1. Type of Well <input checked="" type="checkbox"/> Oil Well <input type="checkbox"/> Gas Well <input type="checkbox"/> Other		8. Well Name and No. SALADO DRAW 10 W0PA FEDERAL 2H ✓
2. Name of Operator MEWBOURNE OIL COMPANY ✓		9. API Well No. 30-025-42837-00-X1
3a. Address HOBBS, NM 88241	3b. Phone No. (include area code) Ph: 575-393-5905	10. Field and Pool or Exploratory Area RED HILLS
4. Location of Well (Footage, Sec., T., R., M., or Survey Description) Sec 15 T26S R33E NENE 185FNL 500FEL ✓		11. County or Parish, State LEA COUNTY, NM

Mewbourne Oil Company has an approved APD for the above well. Mewbourne would like to make the following changes:

- 1 - Change name to Salado Draw 10 W1PA Federal #2H
- 2 - Change surface location to 250' FNL & 530' FWL, Sec 15 T26S R33E
- 3 - Change BHL to 330' FNL & 330' FWL, Sec 10 T26S R33E

OFFICE:	Carlsbad Field Office
TRACKING NUMBER:	DOI-BLM-NM-P020-2017-0280-DNA
CASEFILE/PROJECT NUMBER:	NMNM02965A
PROPOSED ACTION TITLE/TYPE:	Salado Draw 10 W0PA Federal 2H
LOCATION/LEGAL DESCRIPTION:	Section 15; Township 26 South, Range 33 East
APPLICANT (if any):	Mewbourne Oil Company

Figure 1.

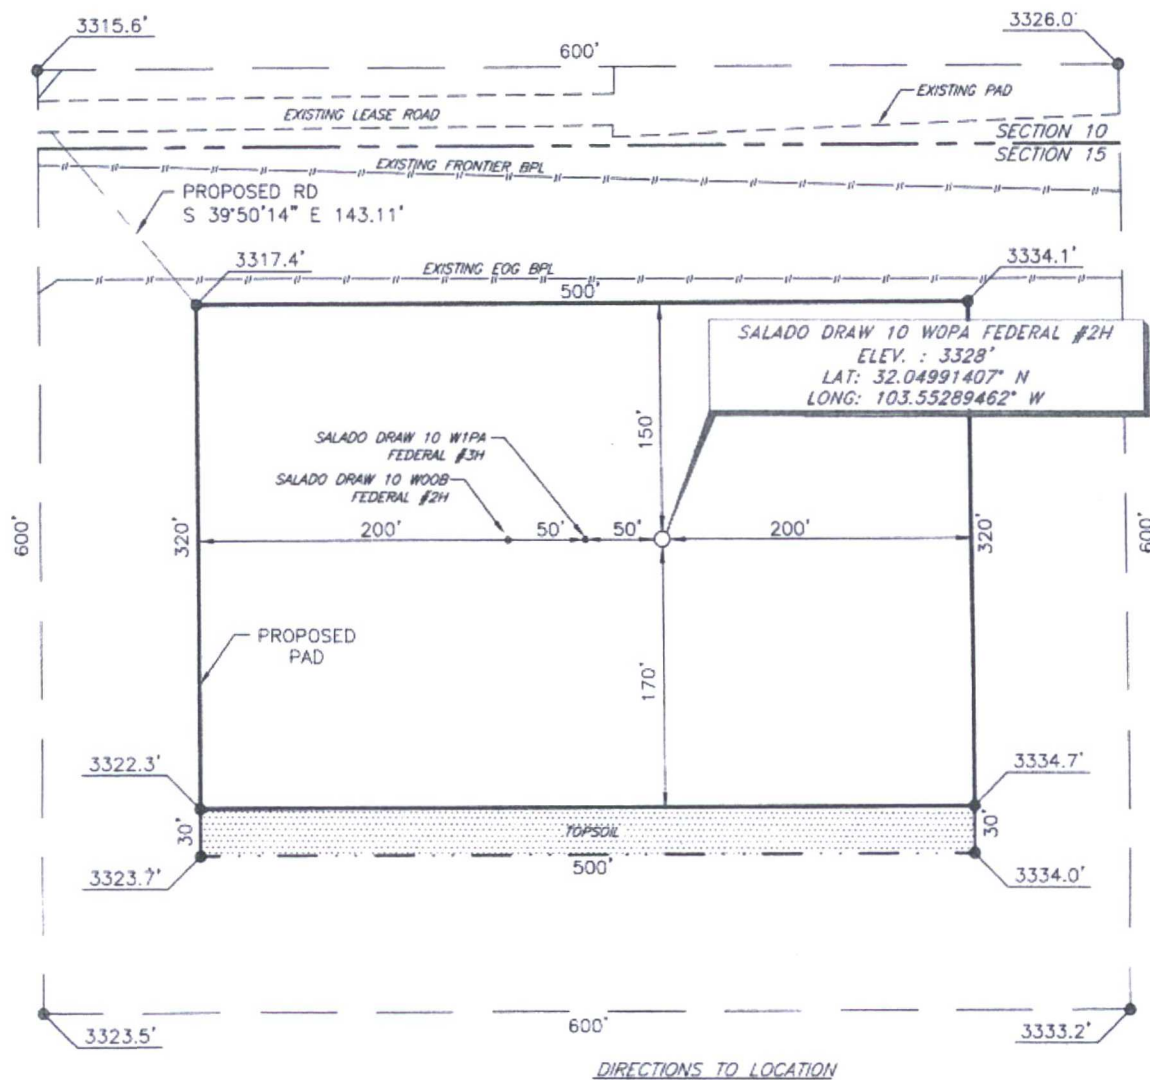
Mewbourne requests to move the well location 65 feet south and 30 feet to the west. The move is required due to a pipeline that was laid through the middle of the location. There will be no other changes to the original surface use plan. The well location is as follows:

Salado Draw 10 W0PA Federal 2H:

Surface Hole Location: 250' FNL & 530' FEL, Section 15, T. 26 S., R. 33 E.

Bottom Hole Location: 330' FNL & 330' FEL, Section 10, T. 26 S., R. 33 E.
